Hill of Fare Wind farm Information Group (HOFWIG)

Objection Document

January 2024

Figure 5.2: Developer's ZTV map – purple/green indicate most/all turbines visible.

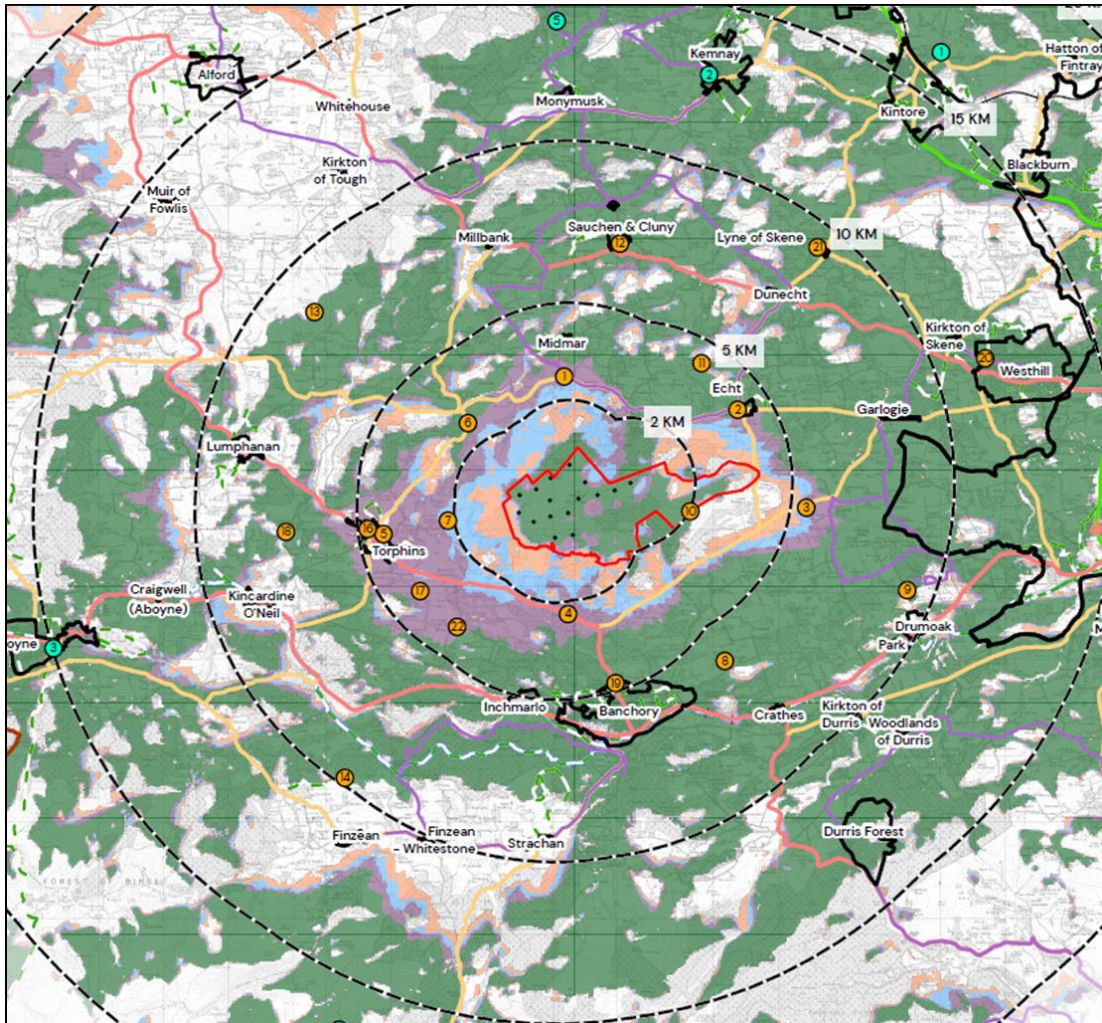
Similarly, it contravenes the Scottish Natural Heritage (now NatureScot) Guidance for *Siting and Designing Wind Farms in the Landscape* which states in Section 3.29 that: *“Narrow bands of uplands between settled and smaller-scale valleys should be avoided, if a windfarm on the hills would dominate the landscape on both sides”*. The windfarm will dominate the views within 15 km where ca. 45,000 people live and will be visible up to 25 km away in Aberdeen City – as demonstrated by the developer’s maps showing the Zone of Theoretical Visibility (ZTV), Figure 5.2.

A comparison of the ZTVs for Hill of Fare (Figure 5.2) and Glen Dye (Figure 5.3) illustrates how the visual impact of the latter is localised by the mitigation of siting turbines within the natural bowl and by avoiding the nearby ridgelines. The Hill of Fare area is too small and comprises a simple ridgeline, so a similar approach is simply not possible.

Figure 5.3: Glen Dye ZTV map.

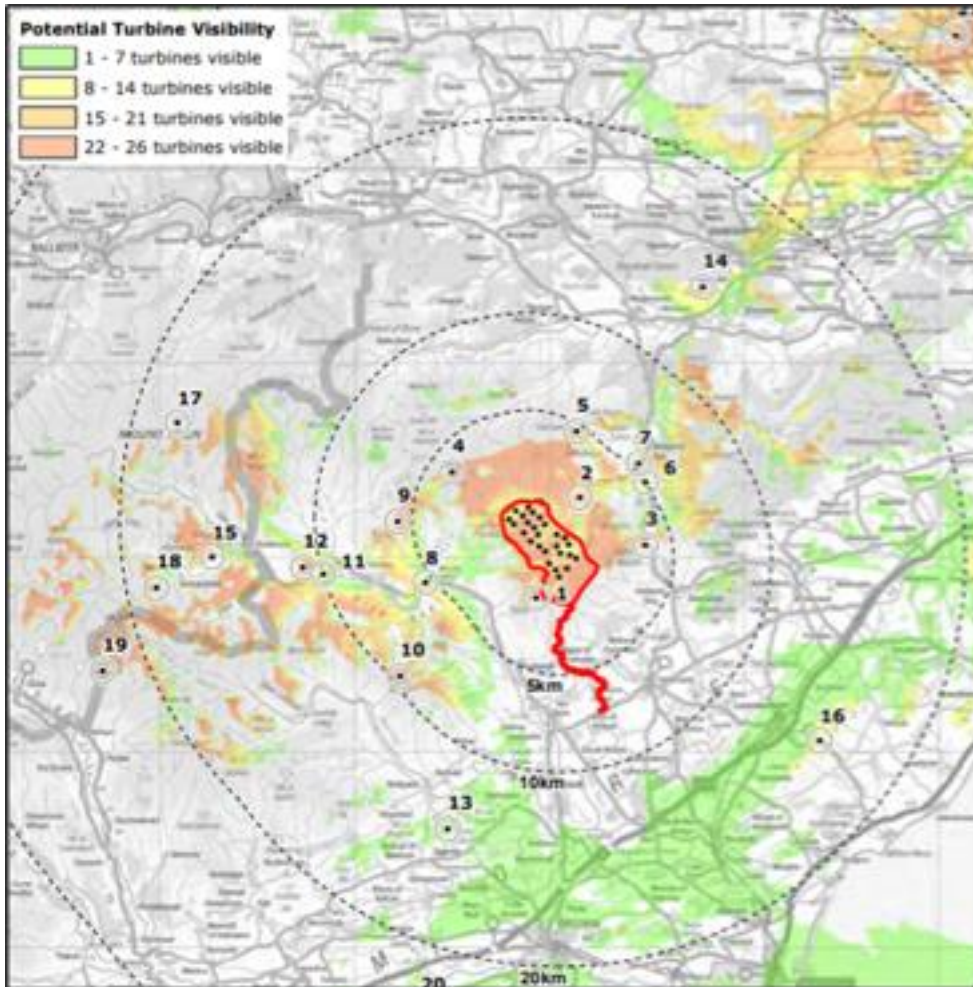
A development on Hill of Fare would be out of character with other wind farms in southern Aberdeenshire such as the recently consented Glen Dye (ECU00000676) which is sited within something of a natural bowl and avoids ridgelines so that outside the immediate area the ZTV is reduced and less than it would be, were it on a ridge (Figure 5.3).

Figure 5.5: Developer's ZTV map with Dee Valley SLA super-imposed (blue line) – purple/green indicate most/all turbines visible.

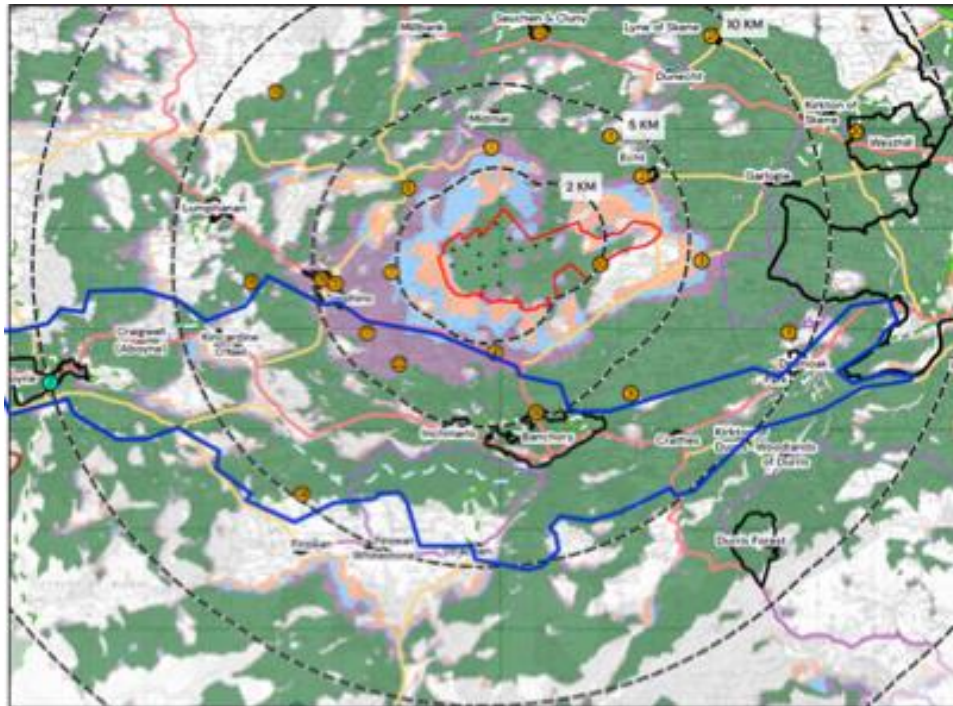
Aberdeen Cumulative Report Final March 2014 (aberdeenshire.gov.uk). The developer's ZTV maps show the development would be visible from ca 70% of the Dee Valley SLA (Figure 5.5).

Locating a large windfarm on the Hill of Fare that can be seen from 70% of the SLA, is the paradigm of a failure to take the self-evident impact on the nearby SLA into account. That means that the SNH guidance has not been followed. It also contravenes Policy 4d(i) as it would have significant adverse effects on the integrity of the area or the qualities for which it has been identified. Similarly, it also contravenes the guidance in Aberdeenshire Council: Assessing Wind Energy Developments, Planning Advice PA2023-21, September 2023 which states: “*Any proposal must not affect the integrity of a Special Landscape Area (SLA), as identified Appendix 13 in the LDP*”. [Aberdeenshire Local development Plan - October 2022 – Appendix 13 Aberdeenshire Special Landscape Areas](#)

Also, the impact on a designated landscape of the Dee Valley SLA is not localised as the development would be visible from c. 70% of the SLA (see Figure 5.5) and far beyond the 7 km mentioned in the EIAR:

Figure 5.7: Hill of Fare with 3km radius and homes / businesses within that radius circled

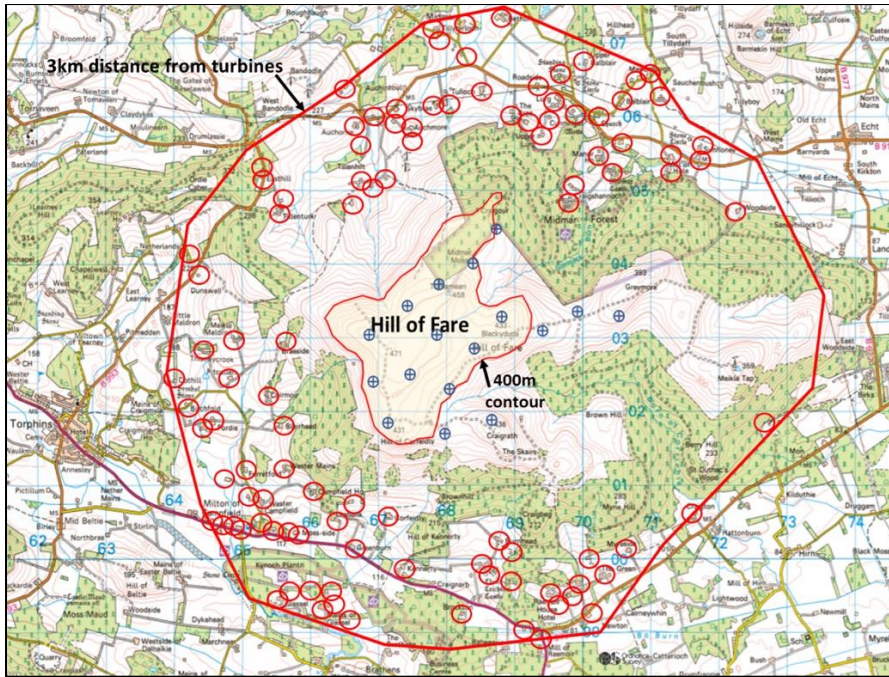
Therefore, the RVAA limit of 2 km is inappropriate and should be expanded to 3 km, which is particularly important as the Hill of Fare is a small area with an unusually high number of residences on its slopes (more than 100 as shown in Figure 5.7).

Figure 9.1: Westhill layout

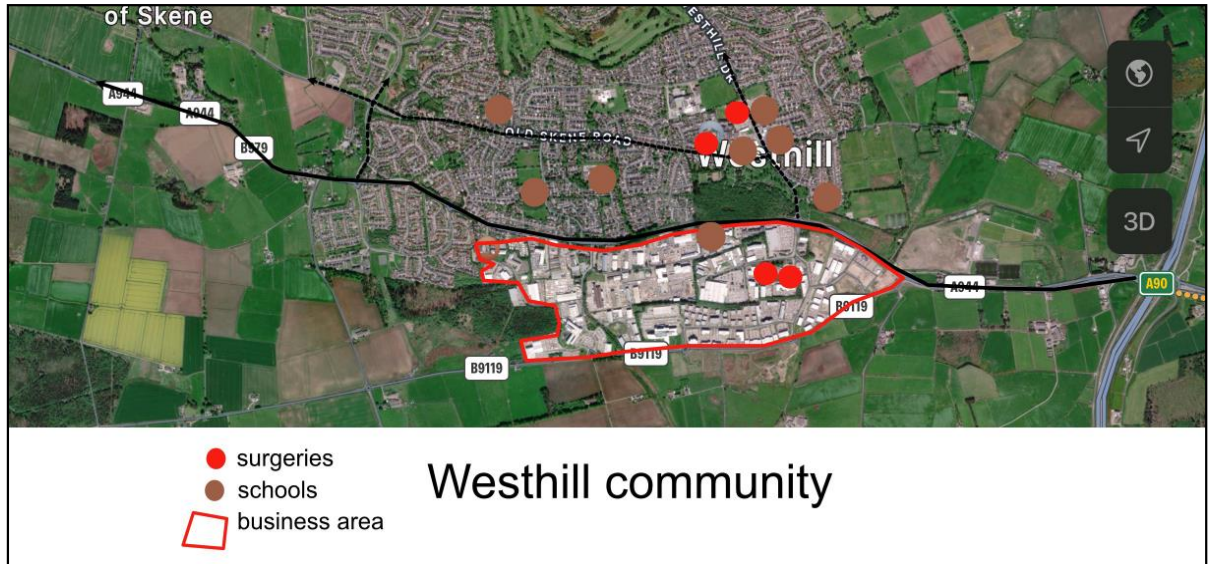
1. Figure 9.1 is a map showing the layout of Westhill and its division of business, residential, schools and medical facilities. The A944 splits them and of particular interest to residents are the medical facilities.
2. The business area represents over 400 companies of which the largest 11 turnover nearly £500million.
3. The residential area had an electorate of 12,110 in 2020. This project will create significant disruption to the regular lives and connections of the communities.

Figure 13.1: UK Grid decarbonisation (BERR Net Zero and the Power Sector Scenarios, Feb 2022 https://assets.publishing.service.gov.uk/media/6225dc108fa8f5490e284e85/annex-o-net_zero-and-the-power-sector-scenarios.pdf)

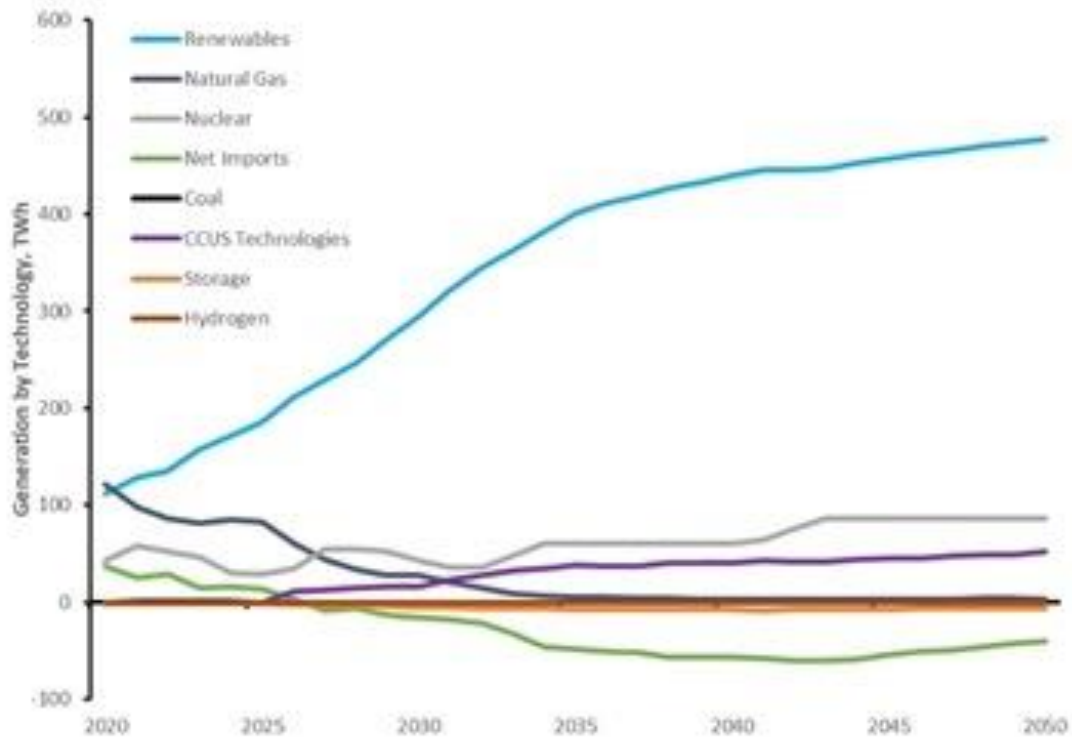
A major flaw tends to make the model overestimate carbon savings – the calculation assumes constant grid mix over development life. The 'black box' model was developed to assess benefits of wind farms in during the 2010s, when grid decarbonisation was in its infancy, with a high proportion of coal fired power. Since 2008, the grid has decarbonised, and will progressively clean up further over coming decades, refer to Figure 13.1 below. By 2023 grid fossil fuel content had fallen to 37%, already less than the constant 44% of fossil fuel assumed by RES.

We believe that representative forecasts of grid fossil fuel content should be used in order to faithfully represent the true carbon savings made by the development and contacted Professor Jo Smith from the School of Biological Sciences at Aberdeen University, who was involved in developing the ‘black box’ model, to discuss this issue.

Figure 14.1 Estimate of number of dwellings within 3km (orange line) and 4km (black line) from turbines based on 2011 census and OS map

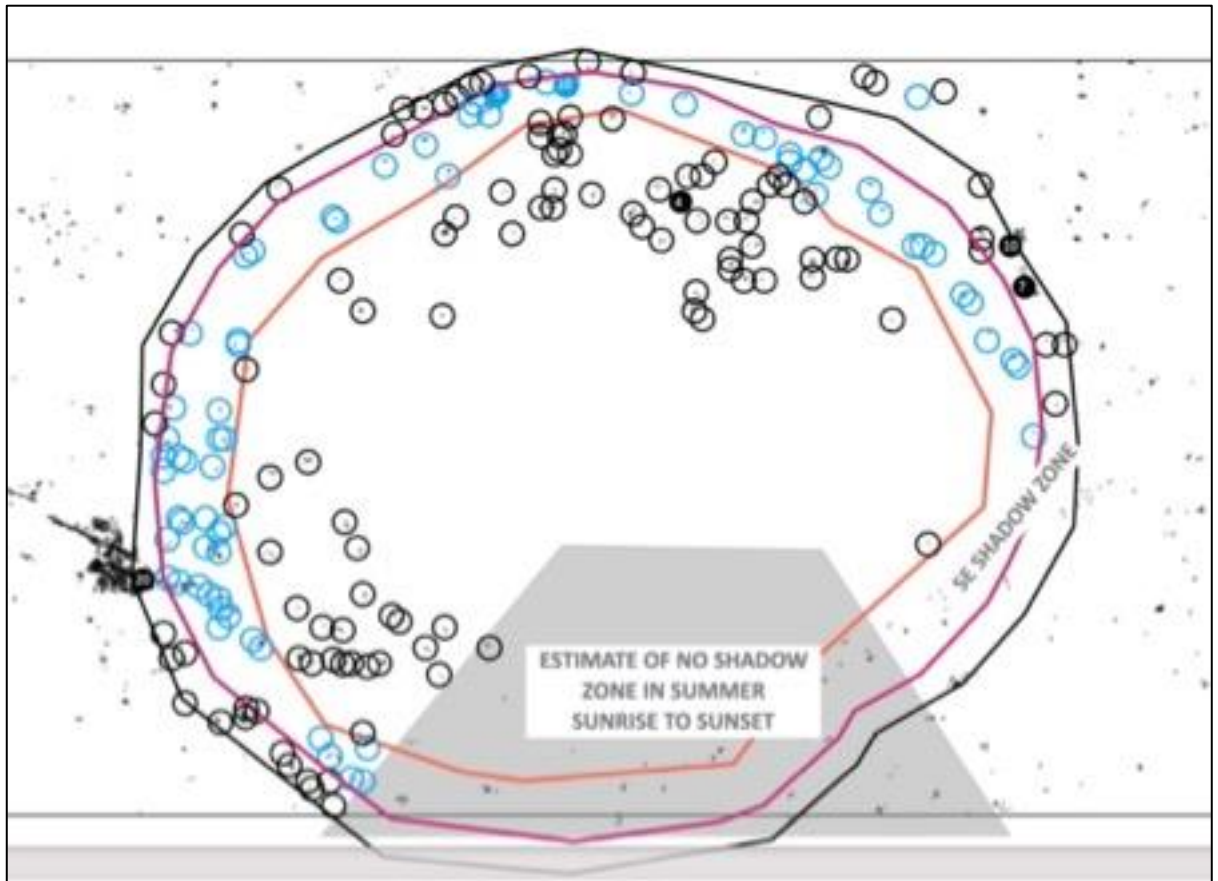
The developer has assessed shadow flicker for properties within 1650m from any turbine, resulting in their estimation that only six properties will be affected.

Due to the prominence of the Hill, we believe that 3 or 4 km is a much more suitable distance to assess. Based on the 2011 census and OS maps we have estimated the number of dwellings in the shadow flicker zone for 3 km (orange line in Figure 14.1) and 4 km (black line in Figure 14.1), which is 78 and 231 respectively. Given that this does not include homes built since 2011 this is likely to be an underestimate. The impact of shadow flicker is likely to be much more significant than assessed by RES.
